STAFF RECOMMENDATION
2000 Benjamin Street
February 15, 2017

Application: New construction-addition
District: Eastwood Neighborhood Conservation Zoning Overlay
Council District: 06
Map and Parcel Number: 08306017100
Applicant: Danny Rosen
Project Lead: Paul Hoffman, paul.hoffman@nashville.gov

<p>Description of Project: Construction of a rear addition to contributing home.</p> <p>Recommendation Summary: Staff recommends approval with the conditions:</p> <ol style="list-style-type: none">1. Double windows on the addition have a four to six inch (4"-6") mullion between them;2. Staff approve the final details, dimensions and materials of windows and doors prior to purchase and installation; and,3. If moved, the HVAC and other utilities be located behind the house or on the non-street-facing side of the house, beyond the midpoint. <p>Staff finds that the application meets Section II.B of the design guidelines of the Eastwood Neighborhood Conservation Zoning Overlay.</p>	<p>Attachments A: Photographs B: Site Plan C: Elevations</p>
---	--

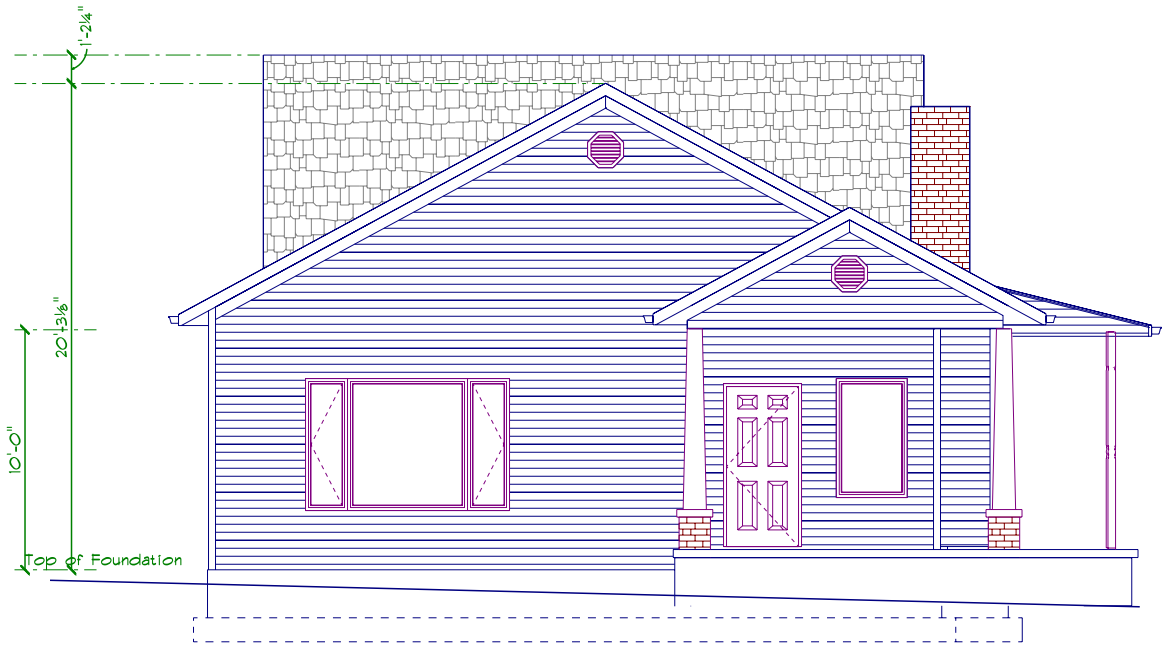
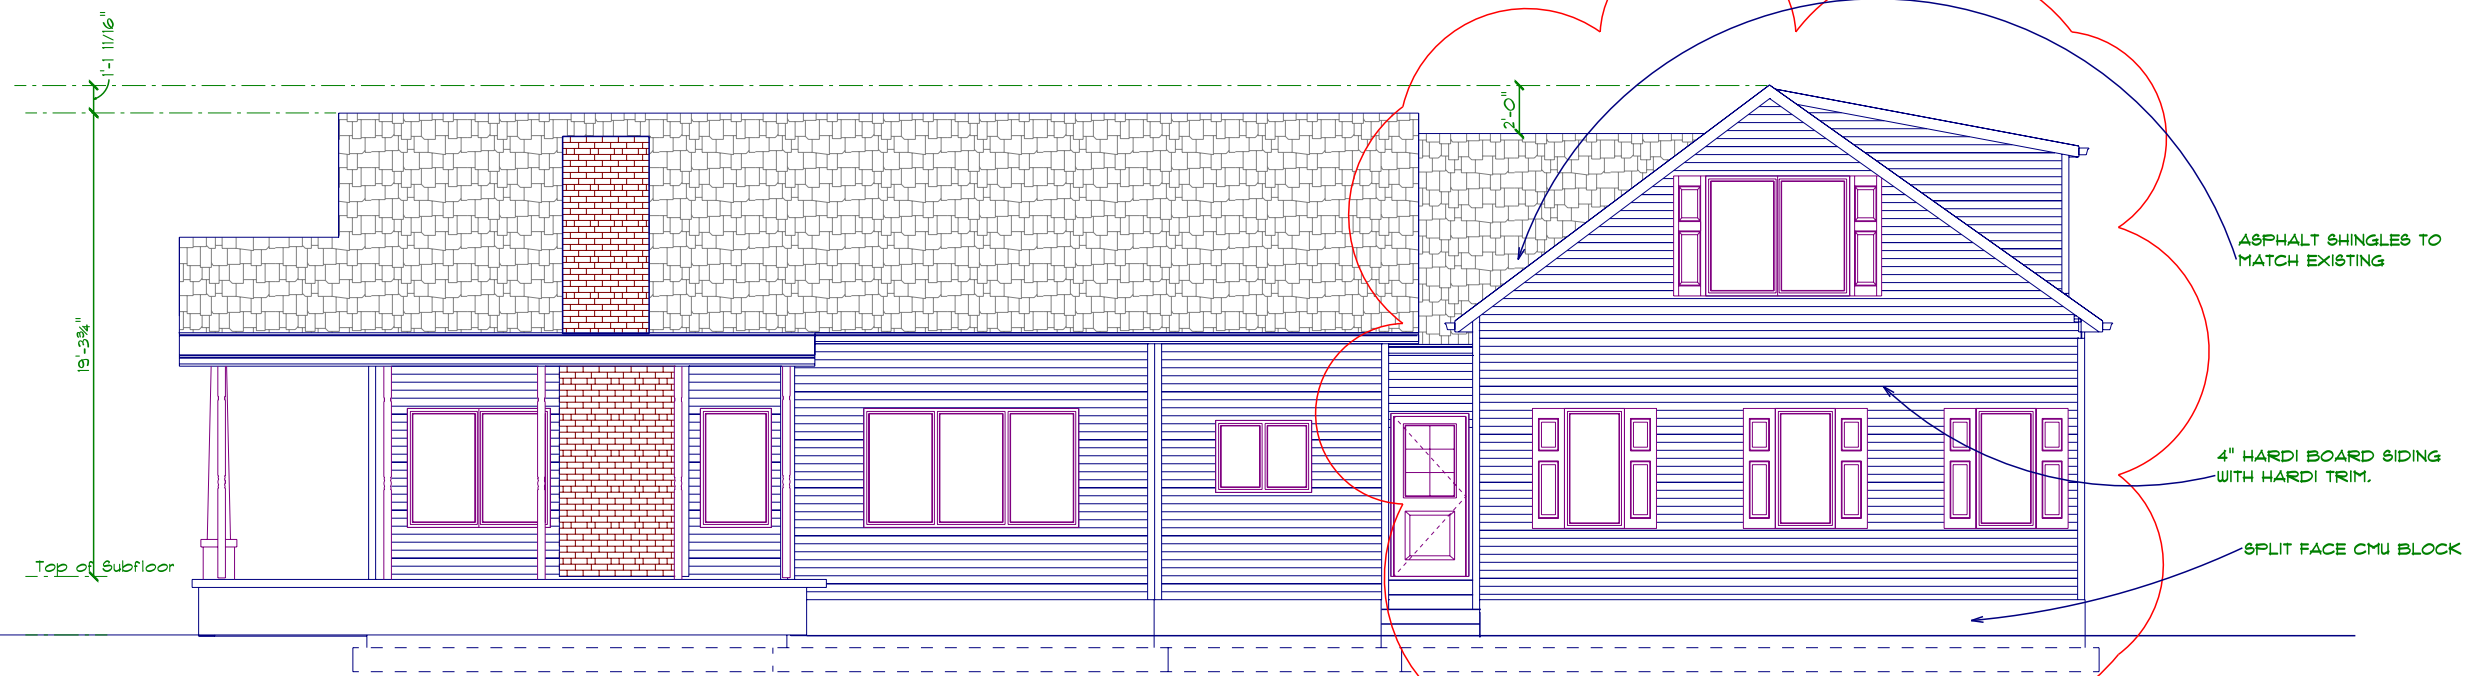
Details on the windows were not clear on the elevations. Staff recommends as a condition of approval that the double windows on the addition have a four to six inch (4" – 6") mullion between them. The proportion of the windows on the rear and left side do not meet historic conditions; however, because of their location they will be minimally visible. Staff recommends having final approval of windows, doors, trim, and any materials that were not specified in the application. With these conditions, the project meets section II.B.1.d for the known materials.

Roof form: The historic home has a gabled roof with 6/12 pitch. The addition has a side gabled roof with 8/12 pitch. A low-pitched shed dormer is located at the addition's rear wall. Staff finds that the roof form of the addition is compatible with the house and with surrounding roofs. The project meets section II.B.1.e.

Proportion and Rhythm of Openings: No changes to the window and door openings on the existing house were indicated on the plans. The street-facing windows on the proposed addition are generally twice as tall as they are wide, meeting the historic proportions of openings. There are no large expanses of wall space without a window or door opening. The opposite side of the addition features two square windows and one horizontal window. As this façade of the addition is in a minimally-visible location, Staff finds these more contemporary windows acceptable. Staff finds the project's proportion and rhythm of openings to meet Section II.B.1.g.

1. The double windows on the addition have a four to six inch (4"-6") mullion between them;
2. Staff approve the final details, dimensions and materials of windows and doors prior to purchase and installation; and,
3. If it is moved, the HVAC be located behind the house or on the non-street-facing side of the house;
